Subject: Response to Request for Additional Information
Regarding the Increase in the
Interim Plugging Criteria for
Byron Unit 1 and Braidwood Unit 1
NRC Docket Numbers:50-454 and 50-456

Reference: D. Lynch letter to Commonwealth Edison Company
dated August 24, 1995, transmitting
Request for Additional Information

NRC Request for Additional Information Number 6

Figure 61-1

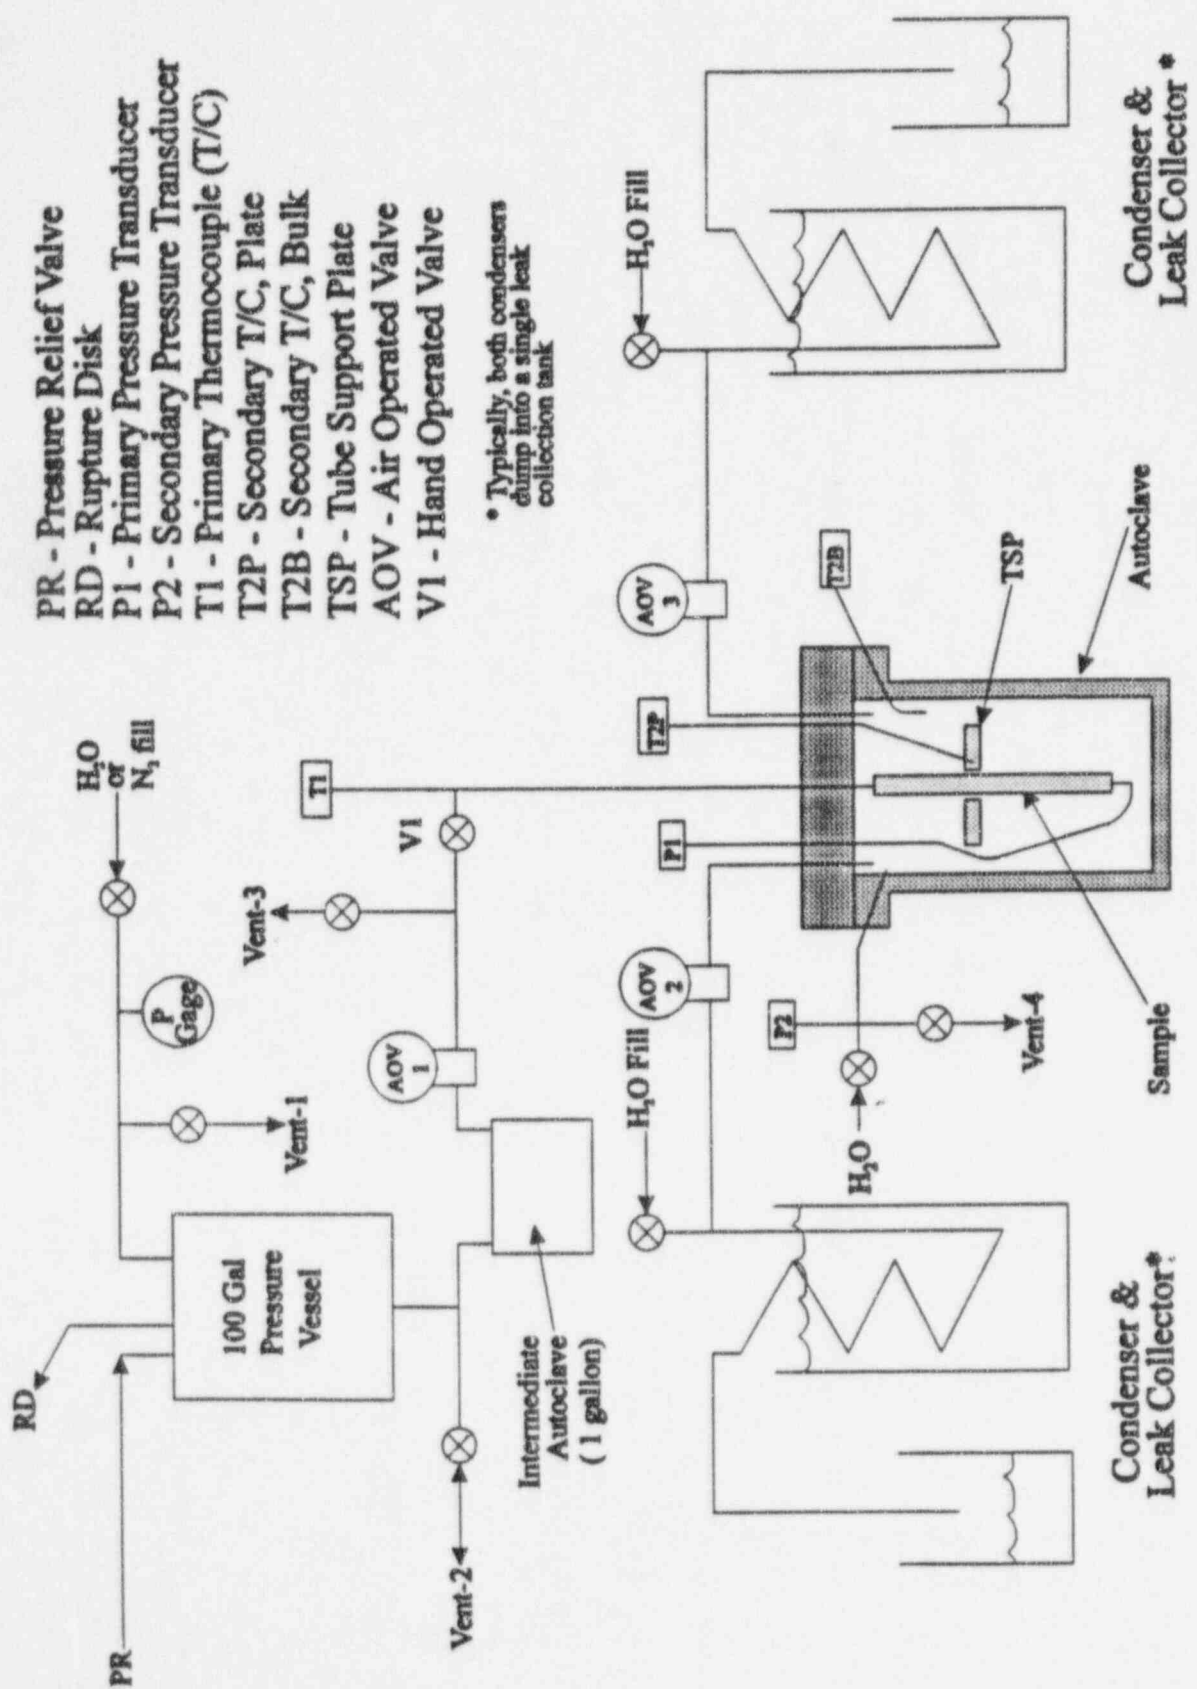
61. To quantify the uncertainty in the SG tube leakage measurements for an indication restricted from burst (IRB), the leakage from a set of orifices has been measured as part of your IRB test program. Discuss any modifications and/or repairs performed on the test rig and/or facility since the original SG tube specimen IRB leak rate testing was performed. Discuss whether these modifications and/or repairs, if any, would alter your conclusions derived from the orifice testing. For example, if a valve in the test rig was leaking by the seat, the leakage from this valve could result in an underestimate of the leakage. If a leaking valve was replaced or repaired prior to the orifice testing, uncertainties in the leakage measurements may not be fully quantified.

Figure 61-1 is a schematic of the test rig that shows the connection among the source tank, shim autoclave, test autoclave, air operated dump valve and the condenser/accumulators. The test process was to establish the desired conditions in the source tank with the dump valve closed, opening the dump valve to vent the test autoclave to the condensers at atmospheric conditions, and collecting and measuring the condensed leakage volume in the accumulators. Thus, any repairs or modifications that could affect the leakage measurement would have to occur between the test autoclave and the accumulators. Only those repairs/ modifications that addressed a test rig condition that resulted in leakage to the atmosphere, downstream of the test autoclave, could have resulted in an error in the measured leak rate, since the measured test leak rate is a dynamic time differential of the accumulated volume with the internal system (source tank to condenser exit) wide open. Leaks upstream of the test autoclave, including the test autoclave head, would only have affected the test process (i.e. ability to establish desired conditions) and would not have affected the leak rate measurement. No tests were performed with any known leakage in the test rig, and no repairs/ modifications were made that could affect the leakage measurements.

The repairs/modifications performed on the hot leak test facility during the time of testing the original specimens (test sequence numbers 1 through 4) and completion of the additional tests (test sequence numbers 11 and 12, and calibrated orifice tests) are summarized below, and their effect on leak rate measurements is discussed:

1. A bypass valve was added to the test and shim autoclaves on the upstream (input) side to bypass the autoclaves in the event of a leak. No leaks were observed, and this valve was never utilized. No leakage through this valve was observed during subsequent testing.

2. Rupture disks were added to the shim and test autoclaves as protection against an overpressure event. The rupture disks had no effect on the testing.

3. The bulk secondary thermocouple was replaced. This repair had no effect on the testing.
4. A leak on the inlet line to the autoclave was repaired by cleaning the leaking connection. The repair was made prior to initiation of a test. Inlet line leaks do not effect the leakage measurement since the inlet conditions are measured at the test specimen, and the outlet (leakage) flow is condensed and collected.

5. The air operated valve on the condenser loop 2 was stuck open at the end of a test during sequence 11-2. Repairs were made prior to continuing any testing. No leakage through the air operated valves was observed after repairs to the valve were completed. Valve maintenance, consisting of lubricating the spring in the actuating mechanism, was performed prior to performing the calibrated orifice tests. The seating and sealing function of the valves was not affected.

The function of the air operated valves is to close the system until the desired primary conditions are established in the system, then to open the system to the condensers at atmospheric pressure so that leakage through the test specimen occurs. Leakage through either valve would have prevented establishing loop equilibrium prior to venting to the condensers, and would have been observed as an increase in the condensed leakage volume prior to initiating the test. The increase volume in the accumulators would not have affected the leak rate measurements since these are made as a dynamic time differential of the accumulated volume during the test with the system wide open.
